- Request - Major Site Plan Review for a New Parking Lot
- Location - 1913 Spielbusch Avenue
- Applicant / Owner - City of Toledo
One Government Center
Toledo, OH 43604
- Civil Engineer - The Mannik & Smith Group
1800 Indian Wood Circle
Maumee, OH 43537

The staff recommends that the Toledo City Plan Commission **approve** SPR25-0004, a Major Site Plan Review for a New Parking Lot at 1913 Spielbusch Avenue for the following **two (2) reasons**:

MAJOR SITE PLAN
TOLEDO CITY PLAN COMMISSION
REF: SPR25-0004
DATE: March 13, 2025
TIME: 2:00 P.M.

SITE PLAN

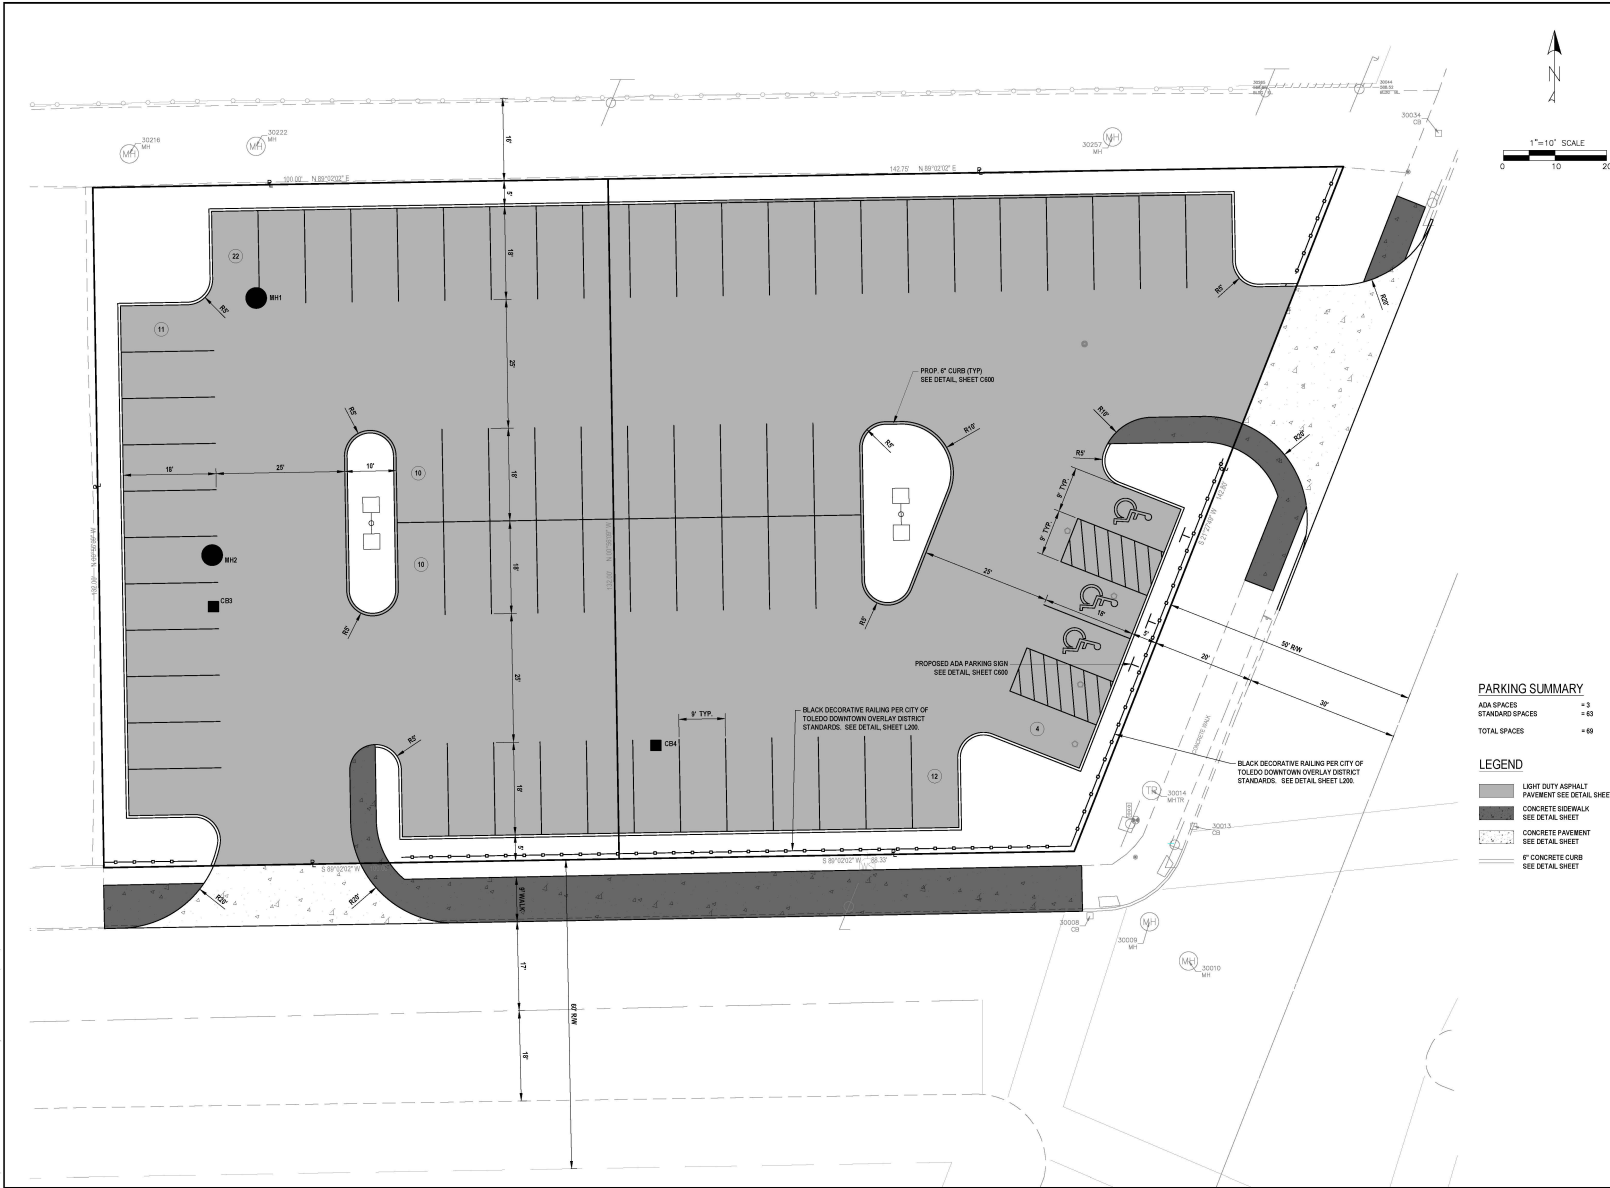
Two points of access are provided to the off-street parking lot, one from Spielbusch Avenue and one from Southard Avenue. These access points are located the furthest points possible from the intersection of Spielbusch and Southard Avenues. There are sixty-nine (69) parking spaces depicted on the site plan, three (3) of which are van accessible spaces. The proposal complies with the required accessible parking spaces as two (2) auto accessible and one (1) van accessible parking spaces are required based on the number of parking spaces provided.

Bicycle parking slots are required per the Off-Street Parking Schedule in TMC§1107.0304, in the amount of one (1) bicycle parking slot per ten (10) parking spaces. Seven (7) bicycle parking slots are therefore required. The applicant has indicated that the parking lot is to be used by City of Toledo employees that are employed at nearby City offices and facilities. As a condition of approval, staff recommends that the required seven (7) bicycle parking slots be provided at nearby City facilities that lack adequate bicycle parking slots for City employees. No less than two (2) bicycle parking slots shall be provided at any one facility.

19. Any spaces reserved for the use by persons with physical disabilities shall adhere to the standards outlined in TMC§1107.1700. A minimum of two (2) car accessible and one (1) van accessible space shall be provided. Three (3) van accessible parking spaces are depicted on the site plan. **Acceptable as depicted.**

20. Bicycle parking slots shall be provided pursuant to Off-Street Parking Schedule "A," (TMC§1107.0300). Seven (7) bicycle parking slots are required; however, no bicycle parking slots are proposed. **Not acceptable as submitted. The required seven (7) bicycle parking slots shall be provided at nearby City facilities that lack adequate bicycle parking slots. No less than two (2) bicycle parking slots shall be provided at any one facility.**

LANDSCAPE PLAN

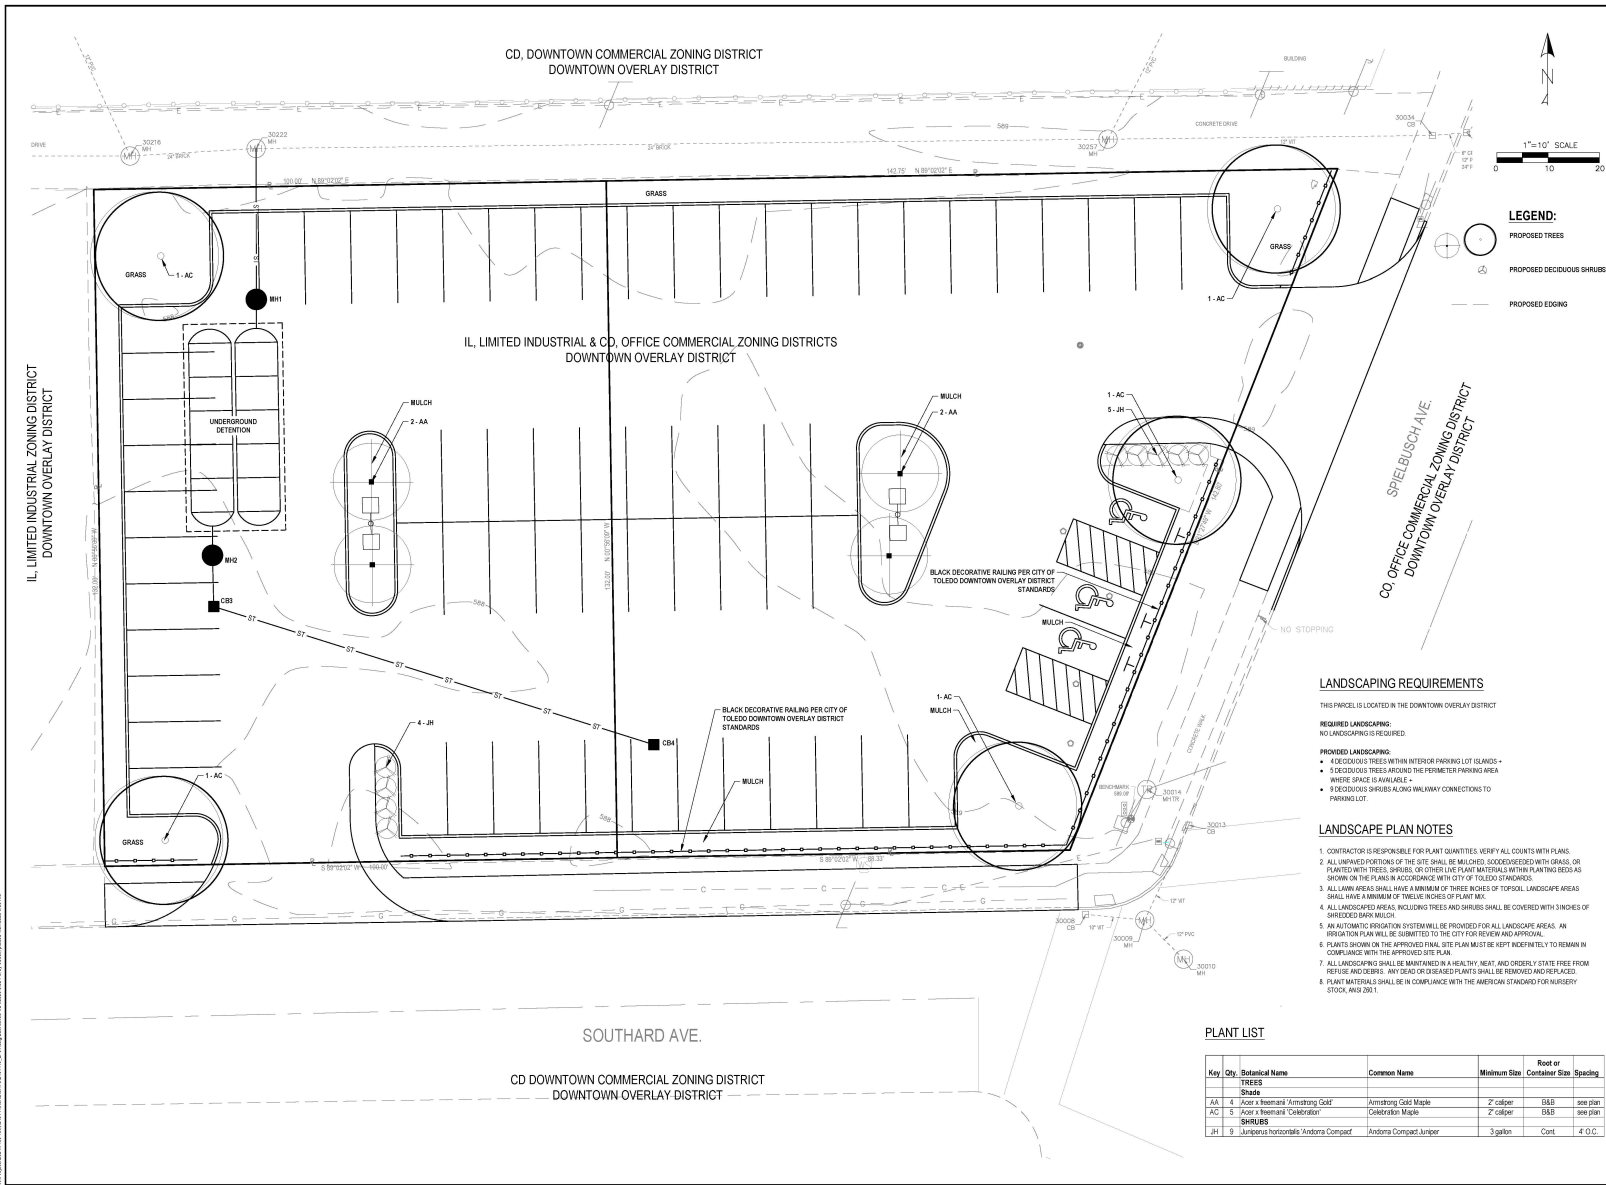
Since the site is located within the Downtown Overlay District, the parking lot is subject to the Urban Commercial Landscape Standards as outlined in TMC§1108.0300. Any part of a lot area not used for buildings, other structures, roads, walks, parking, service areas or accessways must be landscaped with a combination of groundcover, trees and shrubs. The landscape plan complies with this requirement with the exception of the area along Spielbusch and Southard Avenues between a proposed fence and the parking spaces where mulch is indicated. The Urban Commercial Landscape Standards also require perimeter landscaping to be installed along any parking lot area adjacent to a street. The applicant is proposing a forty-two inch (42") high black metal decorative fence at the edge of a five-foot (5') wide mulched area along Spielbusch and Southard Avenues. Per TMC§1108.0305(A.2), providing a forty-two inch (42") high metal tube or solid bar fence, with at least one shrub (planted outside the fence) for every three (3) feet of property line would meet this requirement. To achieve this, the proposed fence would need to be moved closer to the parking spaces and shrubs planted in the amount of thirty-six (36) shrubs along Spielbusch Avenue and fifty-one (51) shrubs along Southard Avenue. Doing so would not only meet the parking lot landscaping requirements, but also the area required to be landscaped on the subject parcel per the Urban Commercial Landscape Standards. Moving the proposed fence and providing the required shrubs is listed as a condition of approval.

Additionally, landscape improvements must be provided in the sidewalk per TMC§1108.0303(B). One (1) shrub or understory tree must be provided for every thirty feet (30') of frontage. Tree grates, or other walkable surface material treatments for the open pits, shall be required. Based on this requirement, four (4) trees are required along Spielbusch Avenue and five (5) trees along Southard Avenue. The landscape plan depicts three (3) trees along Spielbusch Avenue and one (1) tree along Southard Avenue within the subject site. While these are not within the sidewalk, staff has included them in the required number of trees. Therefore, one (1) additional tree shall be provided along Spielbusch Avenue and four (4) additional trees along Southard Avenue as a condition of approval.

- a. Per the Urban Commercial Landscape Standards of TMC§1108.0300, any part of a lot area not used for buildings, other structures, or for roads, walks, parking, service areas or access ways must be landscaped with a combination of groundcover, trees and shrubs. The Urban Commercial Landscape Standards also require perimeter landscaping to be installed along any parking lot area adjacent to a street. The landscape plan depicts a forty-two inch (42") high black metal decorative fence at the edge of a five-foot (5') wide mulched area along Spielbusch and Southard Avenues. **Not acceptable as depicted. The proposed fence shall be moved closer to the parking spaces and shrubs planted in front of the fence in the amount of thirty-six (36) shrubs along Spielbusch Avenue and fifty-one (51) shrubs along Southard Avenue.**

- b. The Urban Commercial Landscape Standards also require one shrub or understory tree to be provided for every thirty (30) feet of frontage, with a minimum tree pit size of four (4) feet by four (4) feet, as outlined in TMC§1108.0303(B). Tree grates, or other walkable surface material treatments for the open pits, shall be required. Four (4) trees are required along Spielbusch Avenue and five (5) trees along Southard Avenue. The landscape plan depicts three (3) trees along Spielbusch Avenue and one (1) tree along Southard Avenue within the subject site. While these are not within the sidewalk, staff has included them in the required number of trees. **Not acceptable as depicted. Five street trees or shrubs per frontage shall be required. One (1) additional tree shall be provided along Spielbusch Avenue and four (4) additional trees shall be provided along Southard Avenue.**
